City of Portland  
Development Review Application

**Application Number:** 2013-187      **Application Date:** 07/26/2013  
**CBL:** 044 A029001      **Application Type:** Level III Site Plan Under 50,000 sq f  
**Project Name:** 6 Unit Building  
**Address:** 133 YORK ST      *condos*  
**Project Description:** Removal of existing structure and replace with a 6 unit bld.  
**Zoning:** R6

**To:** FILE  
**From:** Jean Fraser  
**Subject:** Application ID: 2013-187  
**Date:** 11/8/2013

**Comments Submitted by: Marge Schmuckal/Zoning on 11/8/2013**

CHECK-LIST AGAINST ZONING ORDINANCE

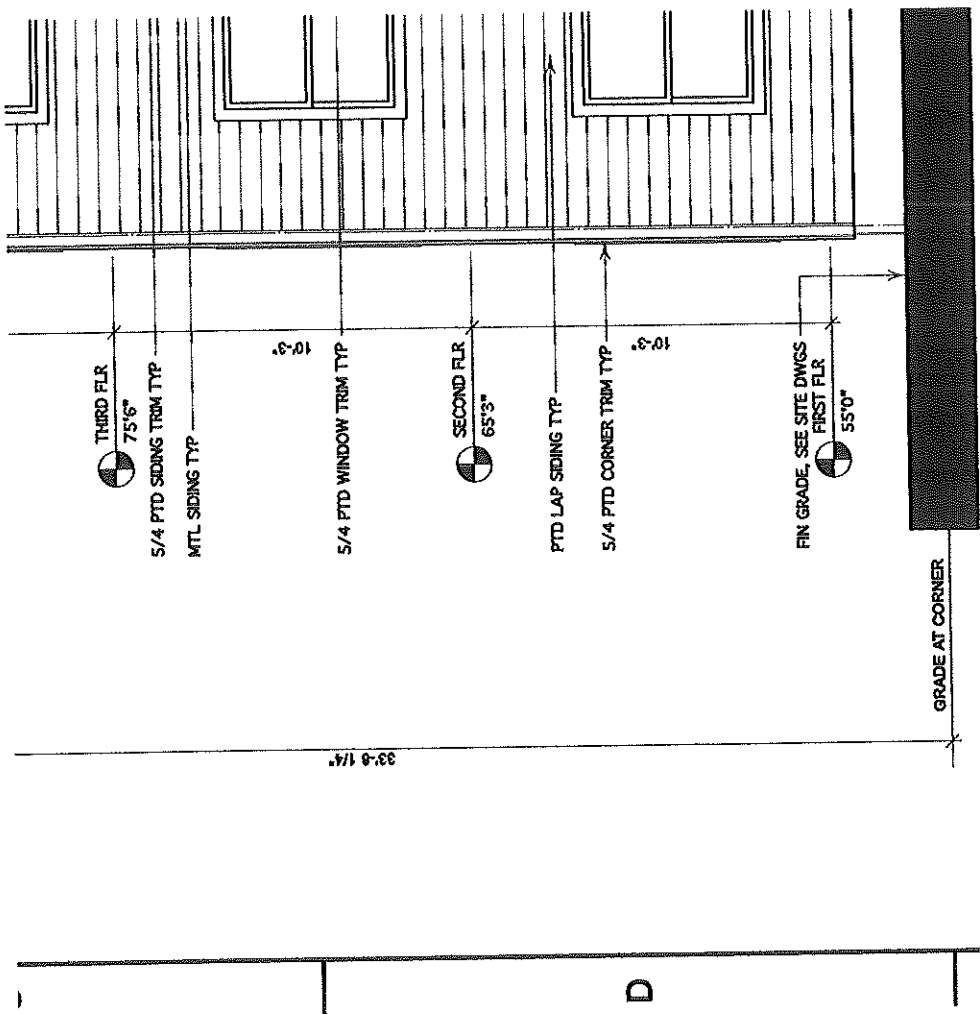
Front Yard - 10' min - 13.85' scaled

Side Yard - using 4-433 5' for side & rear yds - 5' & 11' shown

Height - 45' MAX - 36.5' to Joist beam not top of Joist
